Subject	Further information requested under Section 92 of the RMA 1991 - traffic matters	Project Name	Hobsonville Primary School and Early Childhood Education Centre Designation
Attention	Jo Hart, Senior Policy Planner (Auckland Council)		
Project No.	IA262100		
From	Kerry King (Jacobs NZ Limited), Achini Liyanagama (Jacobs NZ Limited)		
Date	15 February 2022		
Copies to	Steph Taylor (Incite NZ Limited), Chris Horne (Incite NZ Limited), Brontë Pierson (Ministry of Education), James Puketapu (Ministry of Education)

Request for further information in accordance with section 92 of the Resource Management Act 1991

Notice of requirement: Ministry of Education – Hobsonville Point Primary #2 (2 Waka Moana Drive, Hobsonville).

Figure 2-2 Hobsonville Point Road/De Havilland Road and Hobsonville Point Road/Squadron Drive intersections relative to the proposed school catchment zone

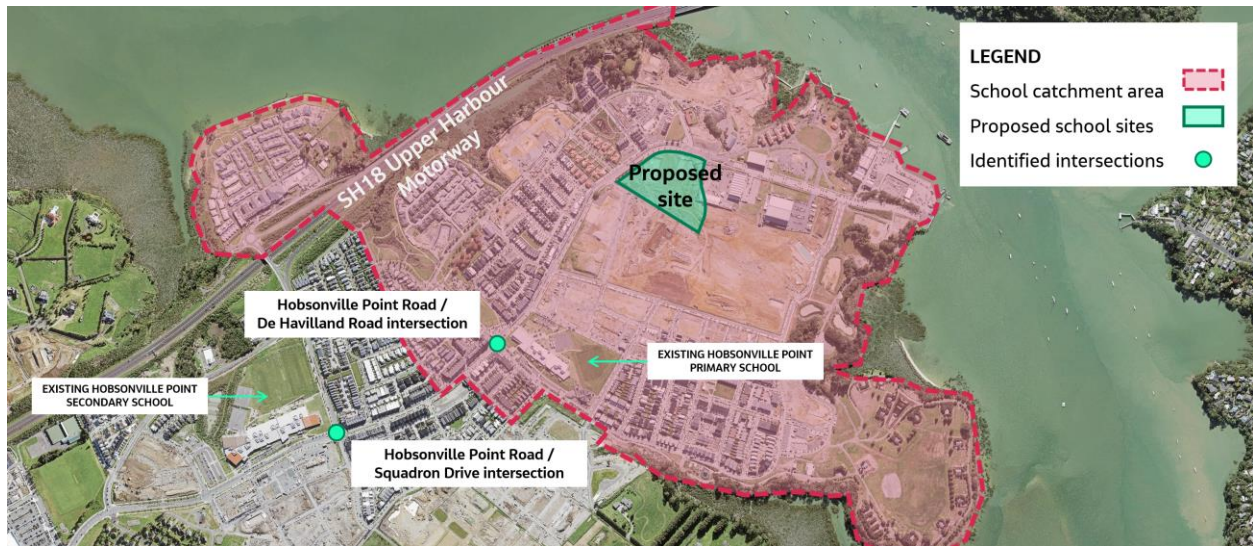
#	Category	Specific request	Reasons for request
T3	Scope of Intersection Modelling Assessments – wider network	<p>The ITA does not consider the traffic impacts of proposed new school and ECE upon the adjoining road network beyond the immediate vicinity of the subject site, while it estimates that the catchment area for the school is expected to extend as far as within 1.5 km of the site.</p> <p><u>Request for information:</u></p> <p>A further assessment of the impacts of traffic generated by the school within the wider catchment area. This should include:</p> <ul style="list-style-type: none"> ▪ Confirmation of additional traffic generated at the intersections of Hobsonville Point Road / De Havilland Road and Hobsonville Point Squadron Road, as the next closest points on the adjoining road network to be affected traffic generated by the proposal. ▪ Undertaking capacity assessments at these intersections, in the event that the proposal is demonstrated to result in significant increases or changes to traffic levels at these locations. 	<p>One of the identified functions of the proposed new school and ECE is to relieve pressure on the existing Hobsonville Point Primary School, located around 0.5 km from the subject site and within the estimated 1.5 km catchment area for the proposed new school and ECE. It is thus expected that the proposal could influence significant changes in travel patterns at the intersections identified above.</p>

Traffic modelling has been undertaken for the three intersections surrounding the school/ECE site (including the Hobsonville Point Road/Waka Moana Drive intersection, Waka Moana Drive/Wallace Road intersection and the Wallace Road/Hudson Bay Road intersection), as all vehicle trips will access the site via at least one of these intersections from the wider road network. The wider local road network provides a large number of route options for those who drive to the school/ECE site and there are many options to redistribute vehicle traffic depending on conditions. The distribution of vehicle trips generated by the school and ECE has assumed that trips originate from within the school zone catchment area and this assumption has been incorporated into the traffic modelling undertaken as part of the ITA.

As shown in Figure 2-2, the Hobsonville Point Road/De Havilland Road intersection is located near the boundary of the catchment area. It is considered likely that traffic within the catchment area would already be passing through this intersection to access the existing school/s and additional trips generated by nearby residential areas within the catchment at this intersection are likely to be very low. The Hobsonville Point Road/Squadron Drive intersection is located outside of the catchment zone area and as a result, no additional traffic has been assumed to be generated at this intersection. It is considered that significant increases to traffic volumes at these intersections resulting from the school/ECE development are unlikely

due to their location relative to the catchment area and that further modelling of these intersections is not required.
